## Historic District Commission Meeting – 2<sup>nd</sup> Floor Training Room Monday, August 24, 2015

Re: 103 E. Maple Street – Exterior Stair & Façade Cap

## 103 E. Maple I Stair & Façade Cap Project

3 FACADE GAP DETAIL  
1" = 1'-0"

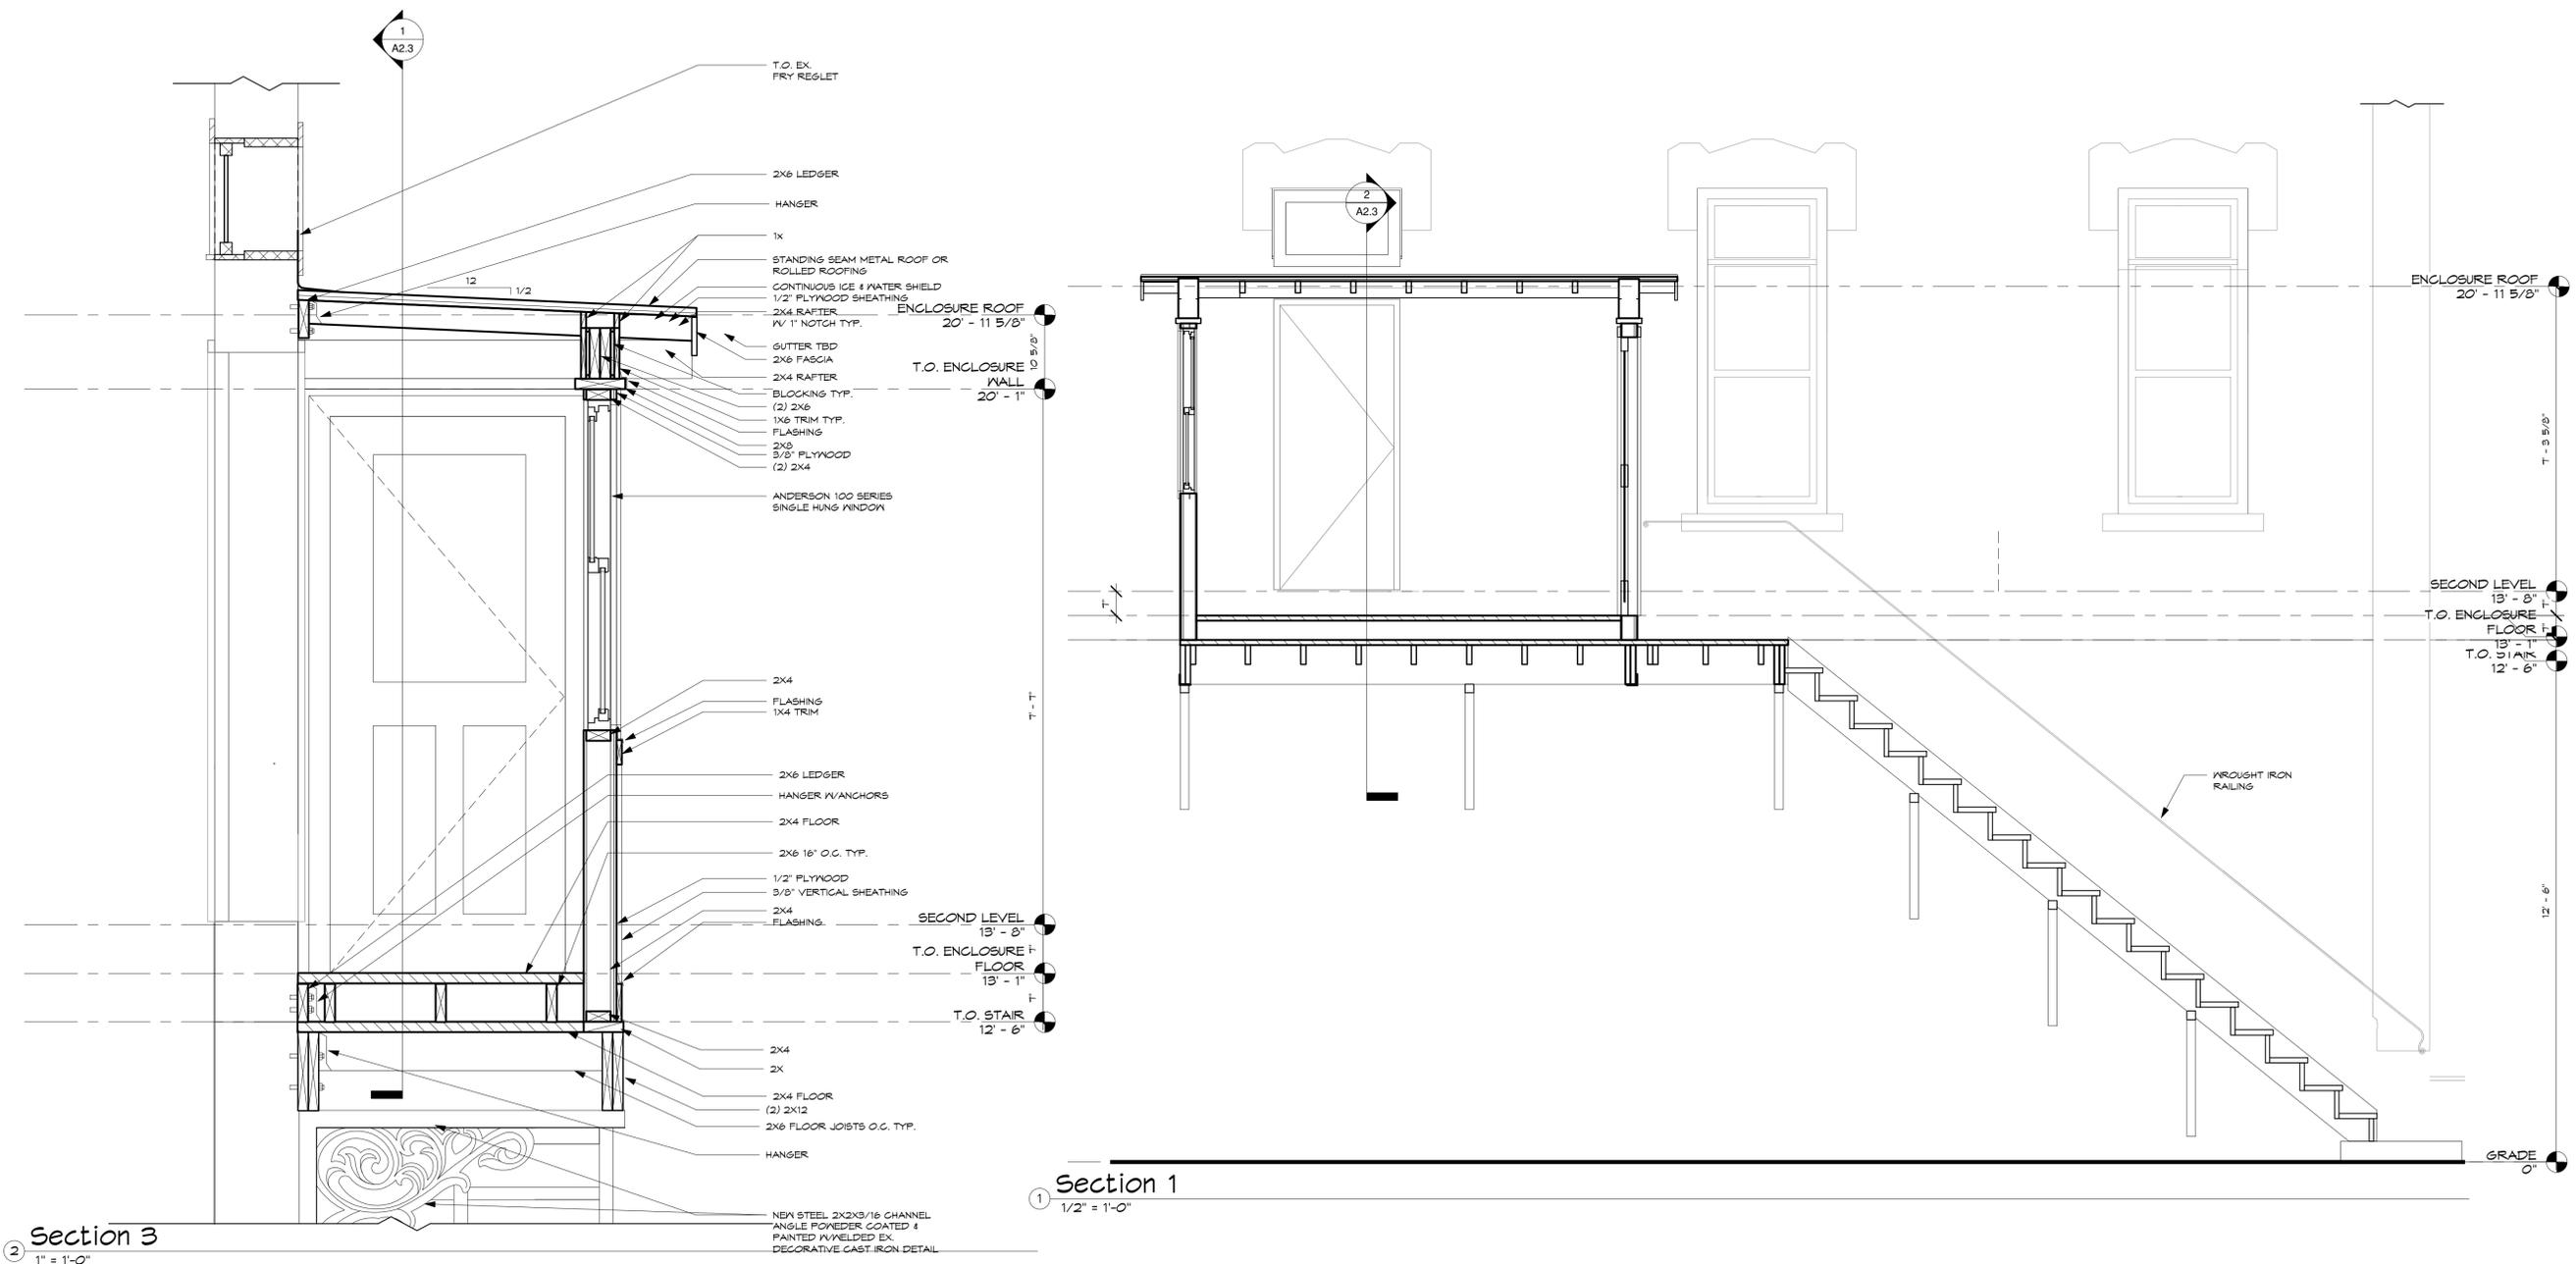
The Study does provide a recommendation to repair the façade cap to "prevent moisture from infiltrating the top of the wall" to prevent further deterioration of the masonry wall below.

The proposed exterior stairs and façade cap appear to fit within the existing sign board and are very similar to previous historical signs in style and letter type.

**The Historic District Commission approve the exterior stair and façade cap proposal for 103 E. Maple Street as submitted by Amanda Herrell-Seyburn of Sedgewick & Ferweda Architects based on the application received on August 20, 2015 on the basis that it is consistent with the standards listed in Section 31-5(e) of the Mason Code.**
